**3 PARRAMATTA SQUARE
PROPOSED PARRAMATTA LIGHT RAIL PROJECT
153 MACQUARIE STREET, PARRAMATTA**
***Assessment of Vehicle Access and
Traffic Implications***

October 2017
(Rev A)

Reference 257/2017

Figure 5.16 Indicative plan – Parramatta Square stop

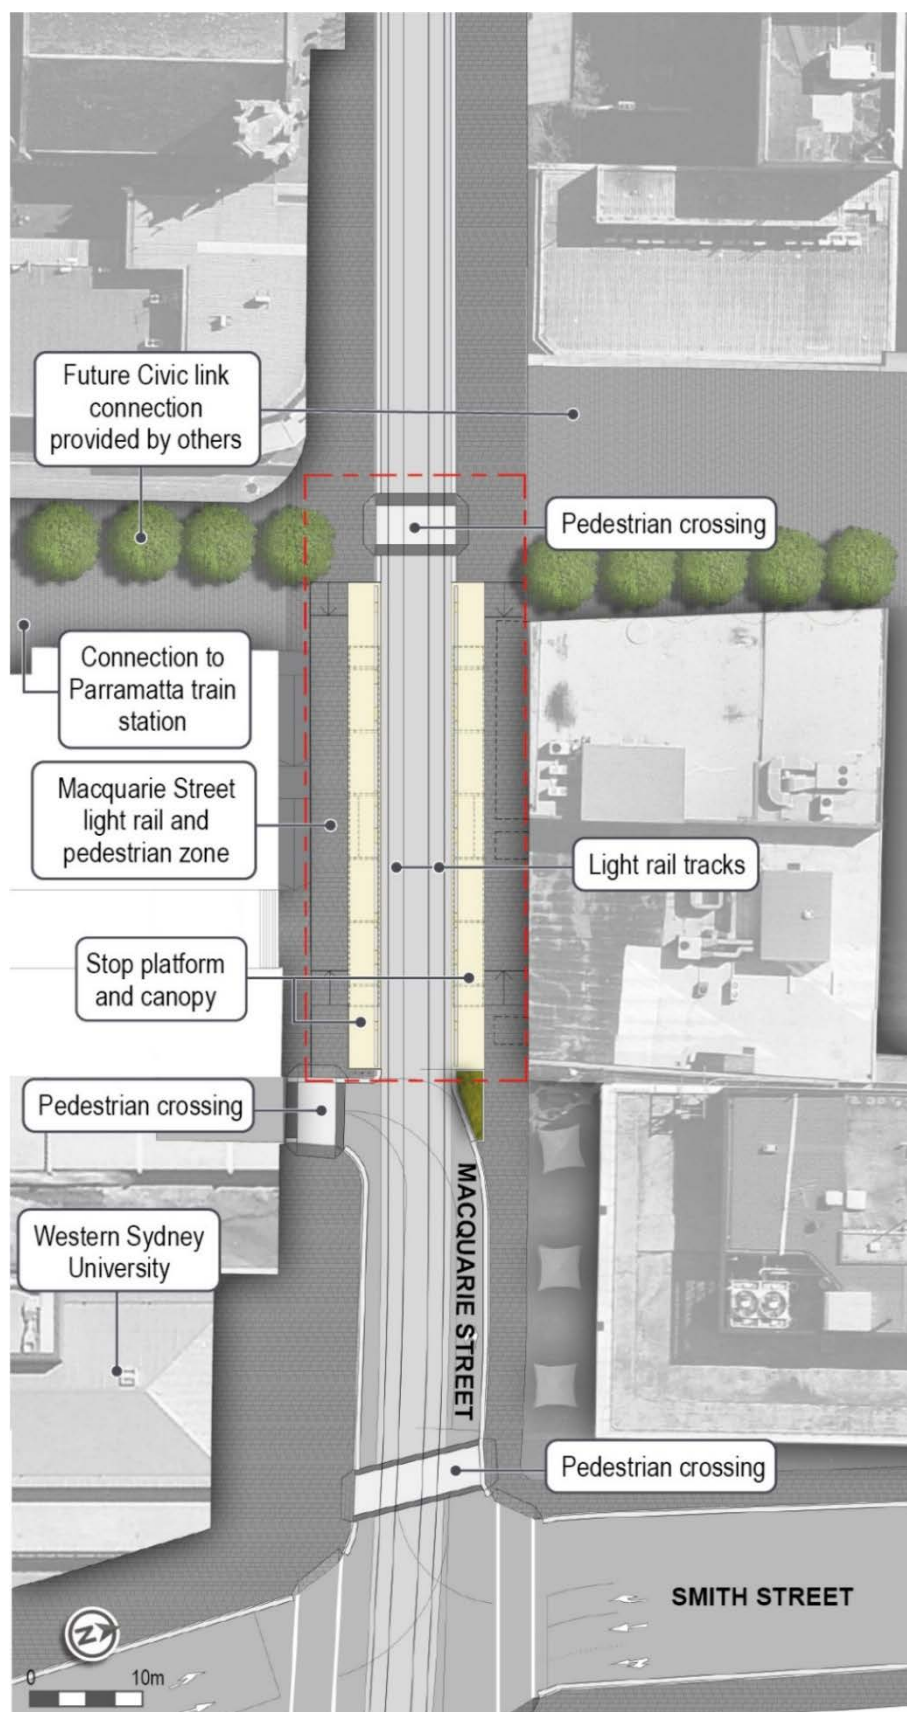
The Stage 1 PLR route involves 2 tracks along Macquarie Street with a 45 metre long platform and stop (Parramatta Square Station) at the 3PS site frontage. The exhibited scheme proposes that the Macquarie Street access to the PS super basement be restricted to egress only with traffic signal control. Because of this proposed change the site will lose its Macquarie Street ingress to the basement, potentially reducing the site's inbound capacity by some 50%.

The PLR scheme also proposes that the future Macquarie Street be restricted to eastbound traffic movements only. Details of the indicative PS Station and the envisaged Macquarie Street/Smith Street intersection layout are provided in the PLR report¹ and reproduced [overleaf](#).

FIG 5

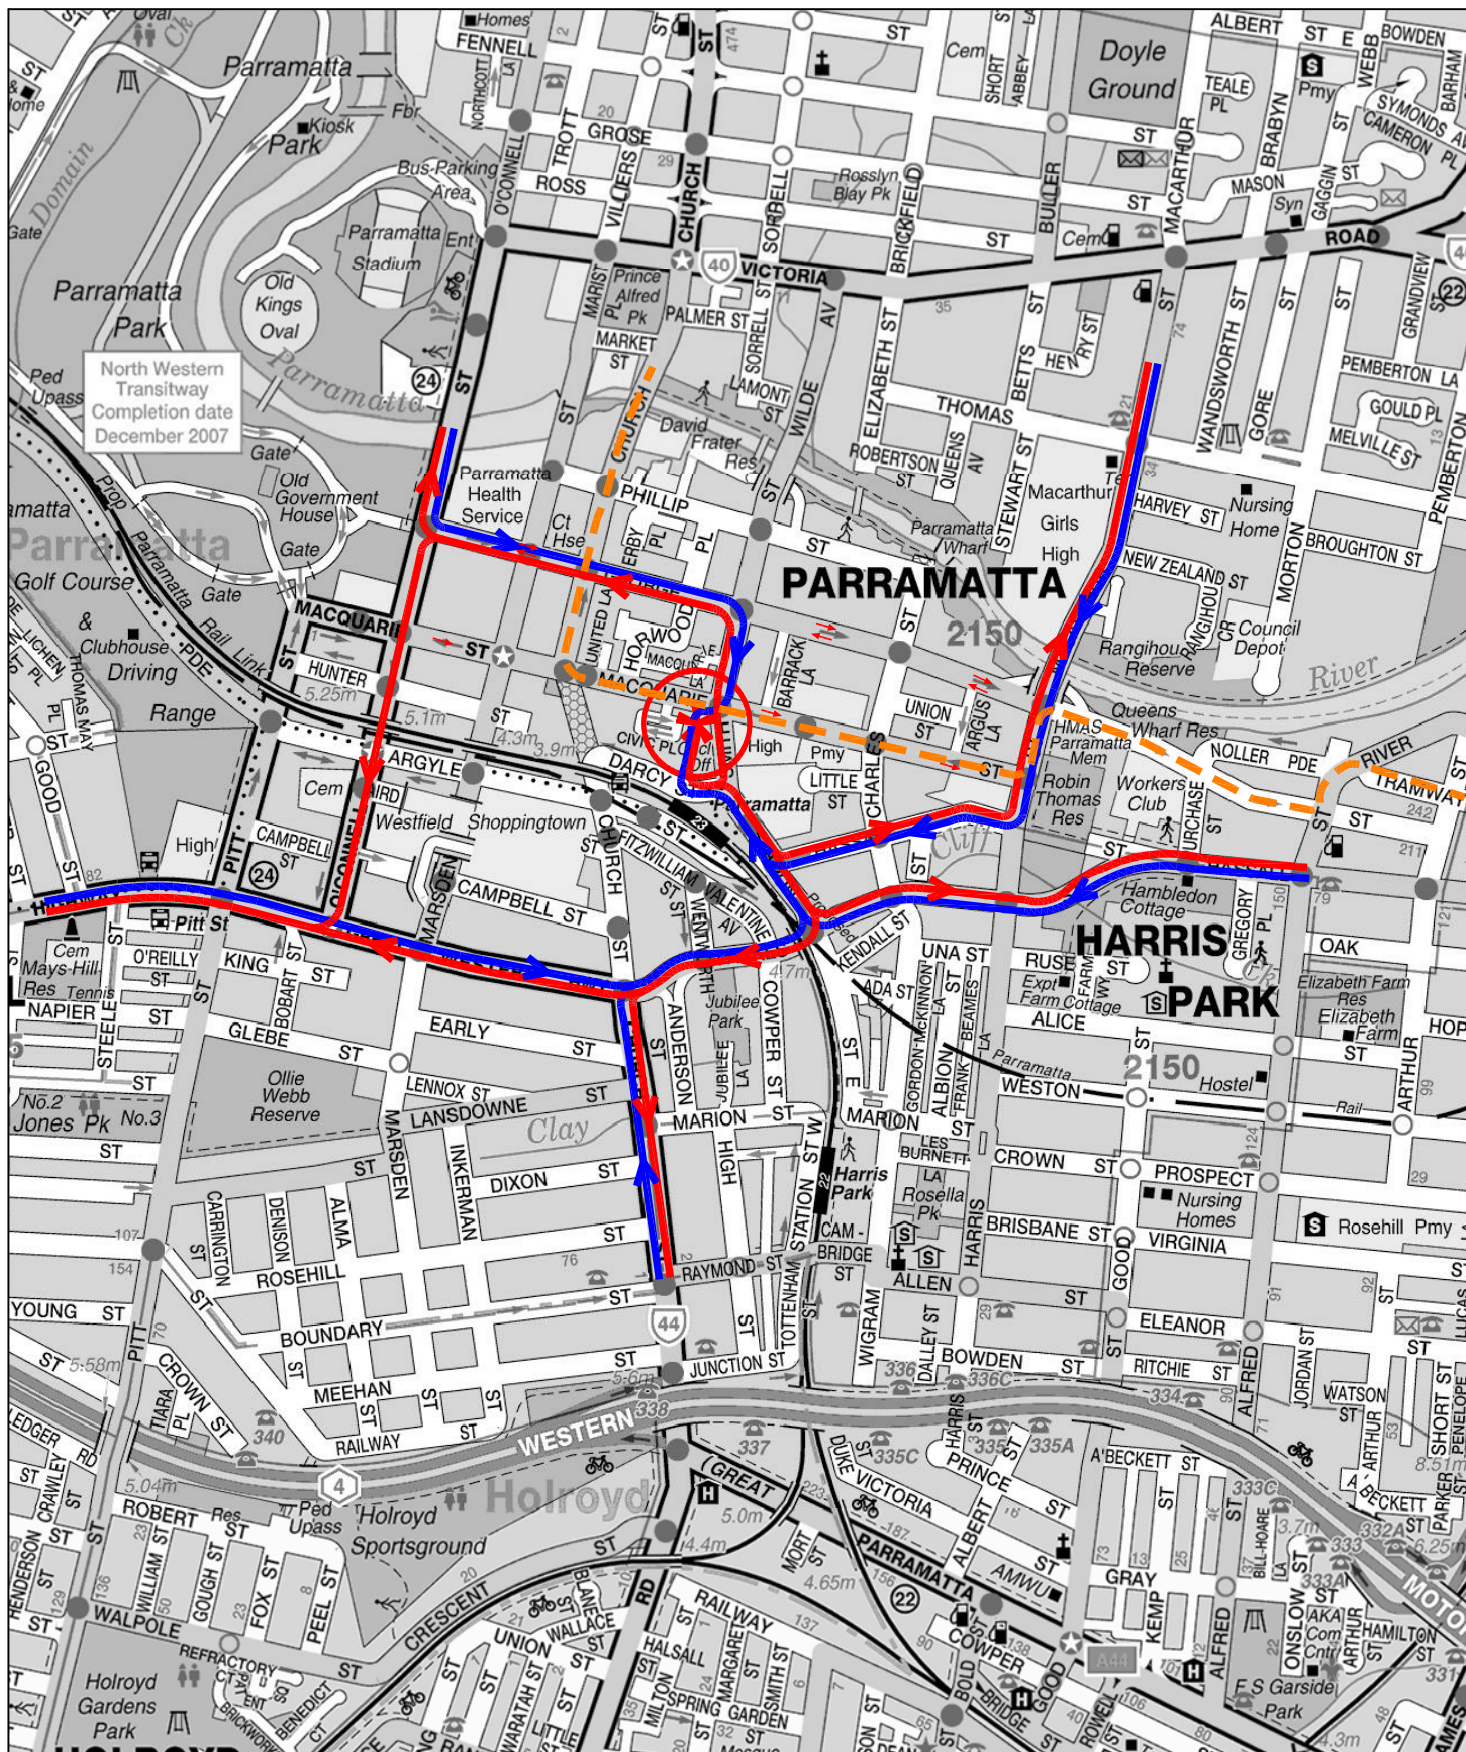
Because it is proposed for the Macquarie Street access to be converted to a signalised exit only arrangement, the overall access capacity for the super basement will now be reduced to a single point of entry only at the Darcy Street ramp while there will be 2 points of egress from Darcy Street and Macquarie Street.

With the proposed restriction this would result in 100% of inbound movements (some 629 vtpm AM and 172 vtpm PM) being required to access the super basement by the Darcy Street ramp (Figure 5).

When the Macquarie Street inbound movements are diverted to Smith Street the intersection level of service falls from B to D and more importantly the Smith Street right turn bay of some 65 metres will be overflowed with 95th percentile queue of some 300 metres essentially extending past Macquarie Street to near the Smith Street/George Street intersection. The excessive right turn queue also reflects in a level of service of F as opposed to the B as assessed for the PS scheme before the proposed PLR changes.

Figure 3.16: Parramatta Square stop access plan

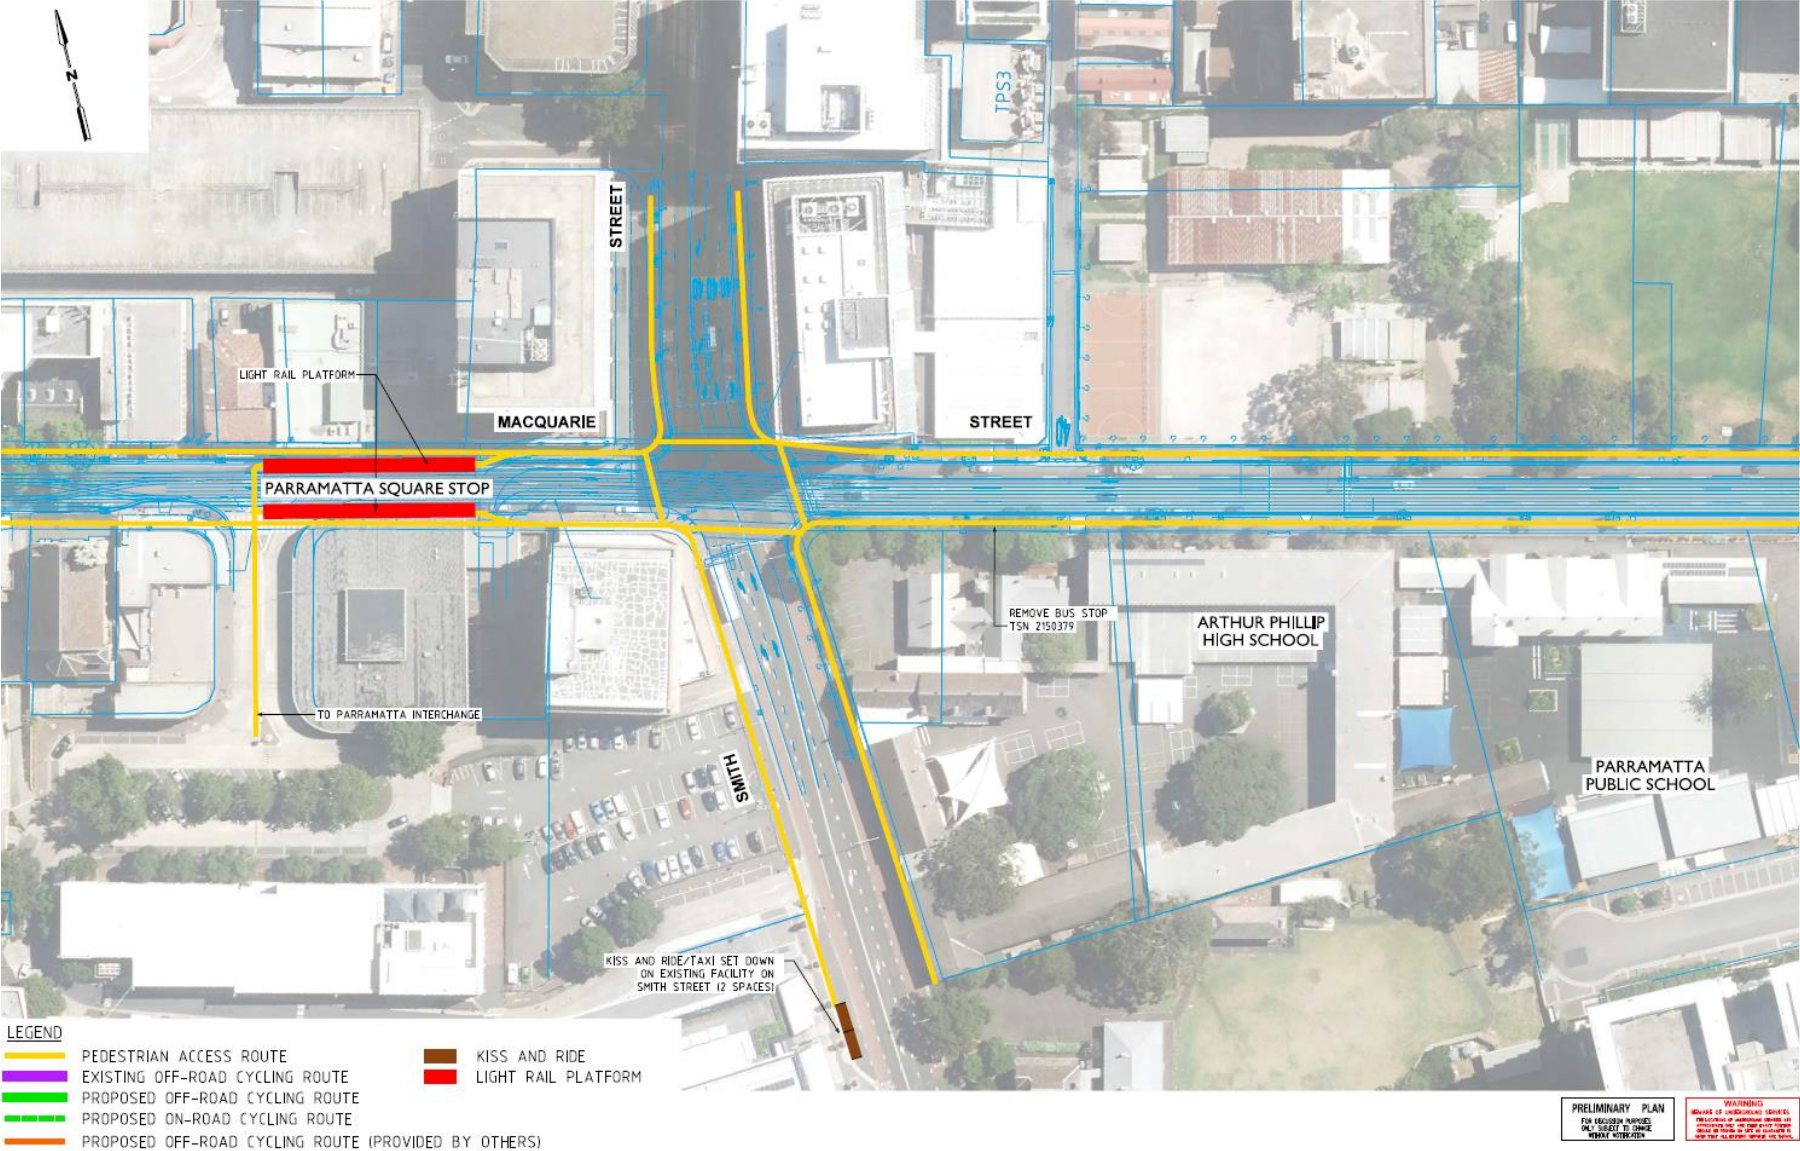
- ❖ the Macquarie Street ingress will be integral to retaining the envisaged level of service of the surrounding road network
- ❖ the PLR Technical Assessment Report indicated a superseded access arrangement which retains the Macquarie Street two-way access via a signalised arrangement and it is proposed that this option is investigated in detail and a design concept is prepared in consultation with RMS, COPC and the PLR Planning Authority
